| Project | IEEE 802.16 Broadband Wireless Access Working Group < http://ieee802.org/16 > | |
| Title | Low-Duty Operation Mode and Wake-up Procedure in Femtocell (15.4.10) | |
| Re: | IEEE 802.16m-09/0044, "IEEE 802.16 Working Group Working Group Letter Ballot #30" | |
| Abstract | Propose to support wake-up procedure during the unavailable interval to shorten the service interruption time and minimize the impact of low-duty operation. | |

Figure 1: wake-up procedure of the Femto ABS in the unavailable interval of low-duty operation mode

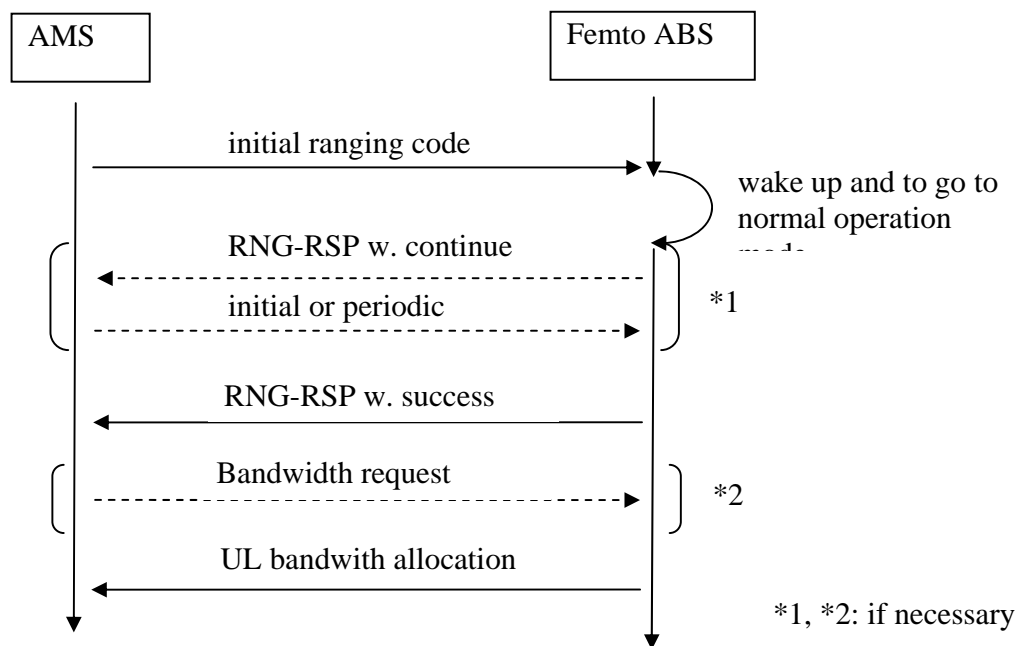
An initial ranging region is allocated for during unavailable interval. Femto ABS regards initial ranging code during unavailable interval as a “wake-up ranging code”. It would be appropriate to inhibit initial ranging for the purpose of initial network entry during unavailable interval. During the unavailable interval, the Femto ABS may keep monitoring the initial ranging region without transmitting any signal. Therefore, the benefit of mitigating interference via low-duty operation mode is still retained while the service interruption time due to low duty operation mode is shortened.

15.4.10.x Wake-up procedure of the Femto ABS in unavailable interval

An AMS intends to connect to a Femto ABS in low-duty operation mode during the unavailable interval may wait until the available interval. Otherwise, the AMS may send an initial ranging code in the dedicated initial ranging region to activate the Femto ABS in low duty mode back to normal operation. AMS shall not attempt to initiate network entry procedure during unavailable interval of the Femto ABS. In order to allow AMS to wake up Femto ABS, the Femto ABS may allocate initial ranging region for during unavailable interval. When the Femto ABS allocate valid initial ranging region during unavailable interval, it shall monitor if any initial ranging codes being sent by AMSs. Upon detection of an initial ranging code, the Femto ABS shall return to normal operation mode immediately and send RNG-RSP for its frequency and timing adjustment. After or together with RNG-RSP with success status, the Femto ABS may allocate UL bandwidth for the AMS to send any message, otherwise, AMS may send Bandwidth request to seek UL allocation.
